ARLINGTON COUNTY, VIRGINIA

County Board Agenda Item
Meeting of July 10, 2010

SUBJECT: SP#95 SITE PLAN AMENDMENT to exceed the lot coverage and setback requirement at 4007 North Abingdon Street (RPC#: 03-071-090).

SITE PLAN
SCALE: 1/16"=1'-0"

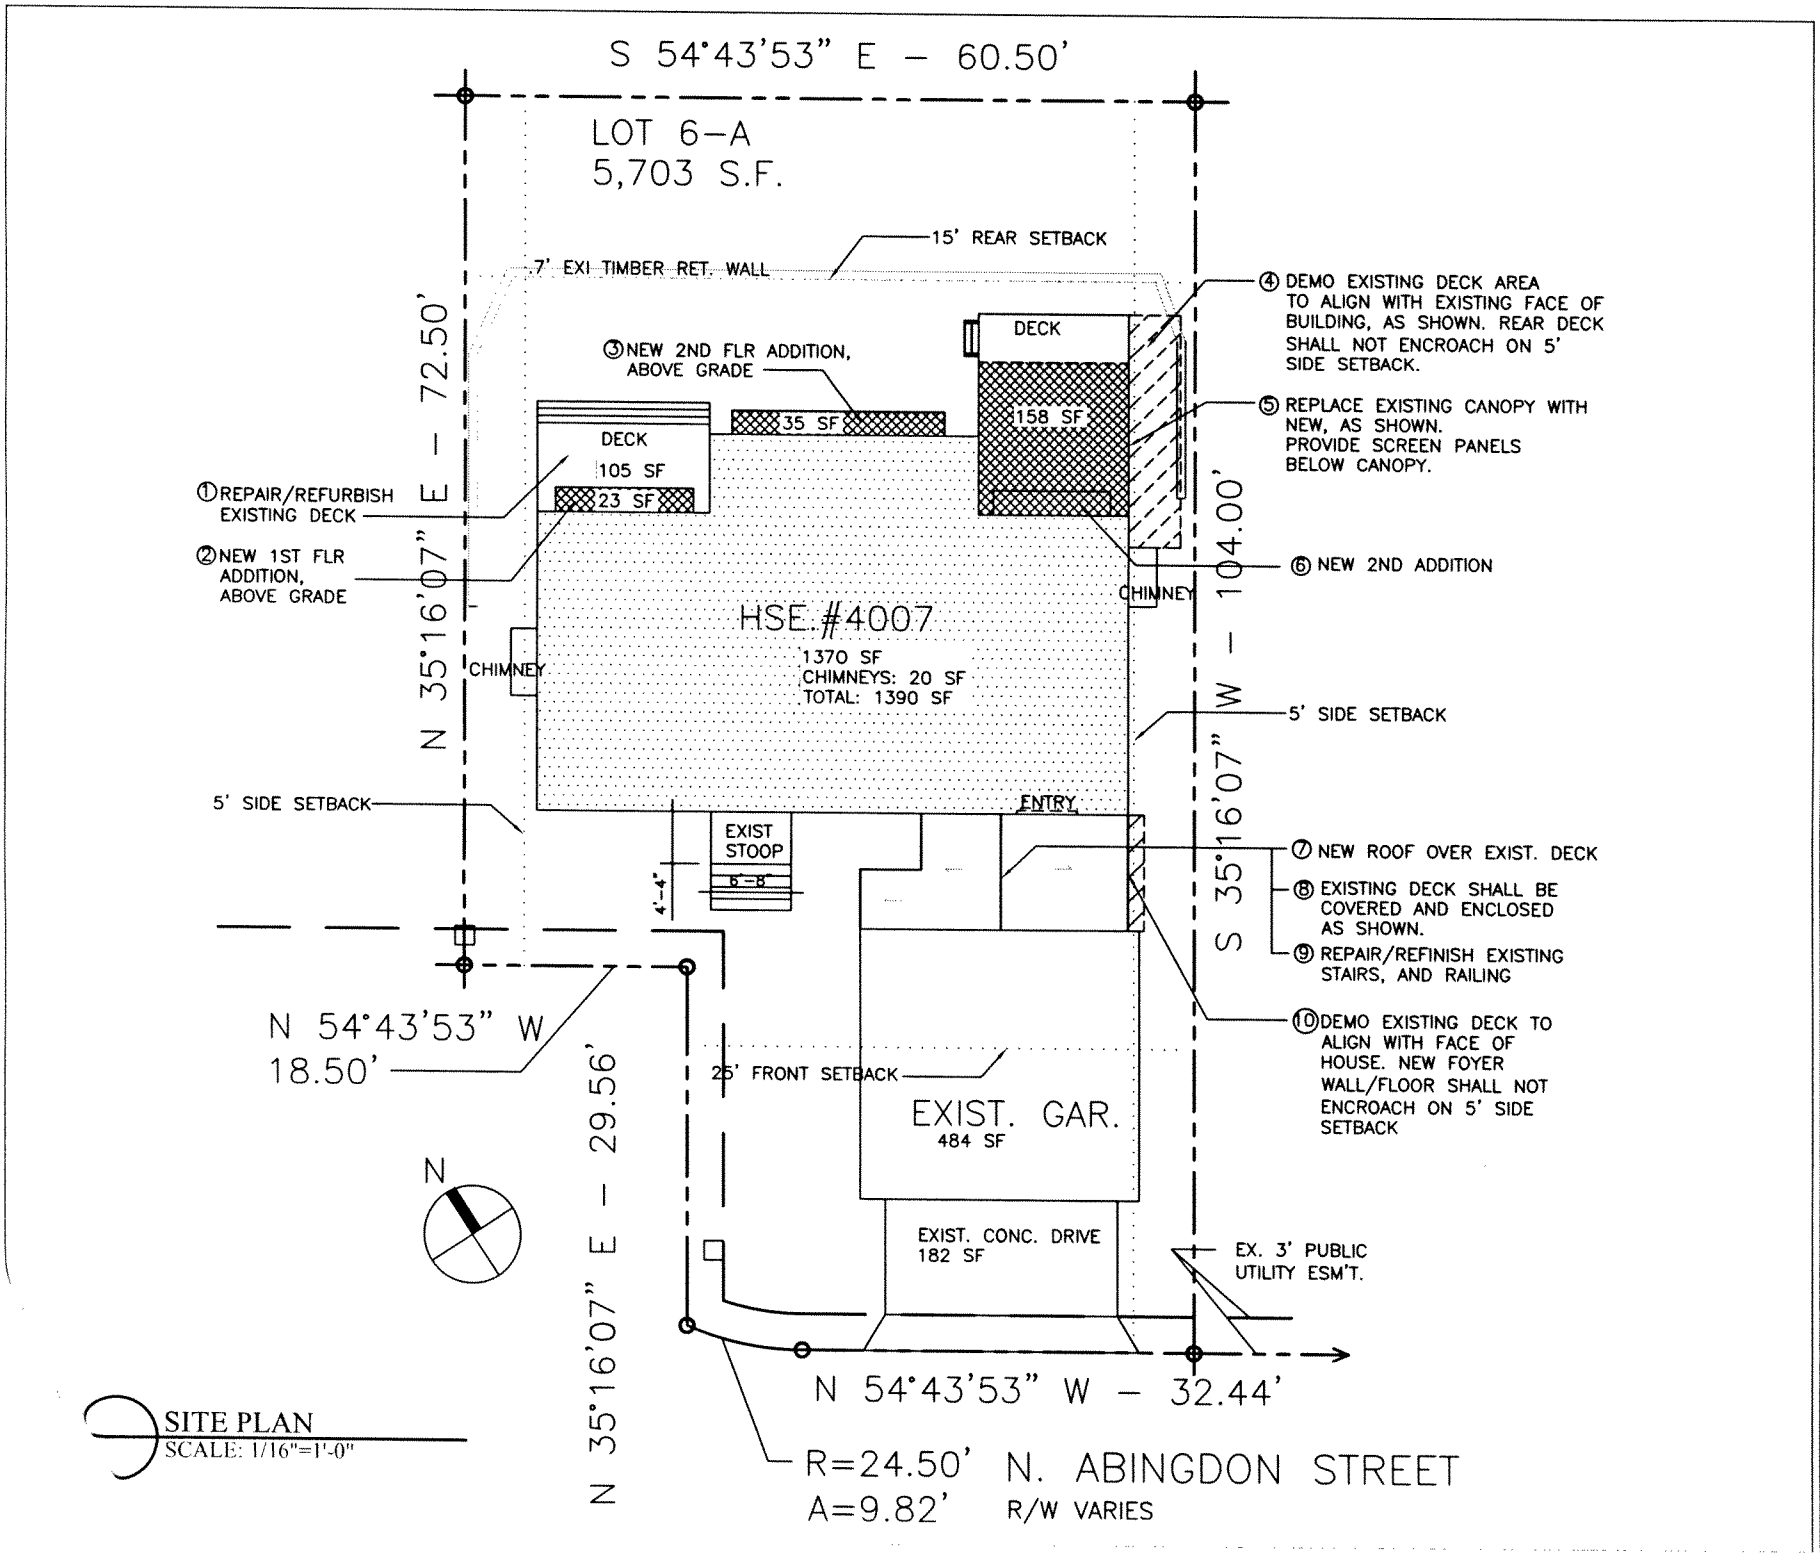
The Zoning Ordinance states that the, "maximum main building footprint coverage on undersized lots in a zoning district shall be the same square footage as permitted on a standard sized lot (e.g., 6,000 sq. ft. in R-6), subject to all applicable setback requirements." The size of the subject lot is 5,703 sq. ft., which is undersized for an "R-10" lot. However, it held to the same maximum main building footprint coverage requirement as an "R-10" lot, which is 25%. Therefore, a site plan amendment is needed to allow the proposed improvements. The improvements would bring the maximum main building footprint coverage for this lot to approximately 40%. The proposed changes to the home would be architecturally compatible with the existing house, and will not negatively affect either neighboring properties or the subdivision's open space. In addition, the Zoning Ordinance states that residential cluster developments are allowed a maximum of 50% total lot coverage over the whole development. At the time of construction the total proposed lot coverage of the entire Black Oak Cluster development was 37%, and since dwelling additions since then have been small, due to the small size of the lots and the large size of the common areas preserved as open space, the proposed increase in lot coverage will not exceed the maximum of 50% total.

Regarding setback requirements, the Zoning Ordinance states that for residential cluster developments, "all buildings, including accessory buildings, shall have a minimum setback and/or yard of twenty-five (25) feet for all exterior boundaries of the site." The garage currently

encroaches within the setback, as that is what was shown on the originally approved lot for SP#95. As the proposed enclosed garage entryway will make the garage part of the main residential building, a modification of setback is needed to allow the house to encroach into the setback. There are no known issues with either the request to exceed lot coverage or with the proposed setback modification. The improvements would be architecturally compatible with the existing home and would not negatively impact adjacent properties.

32. The applicant (the property owner of 4007 N. Abingdon St.) agrees that the enclosed garage entryway, the three (3) rear bump-out additions, and the screened-in porch will be constructed as shown on the plans dated May 20, 2010 created by Architectural Design Studio and approved by the County Board on July 10, 2010.
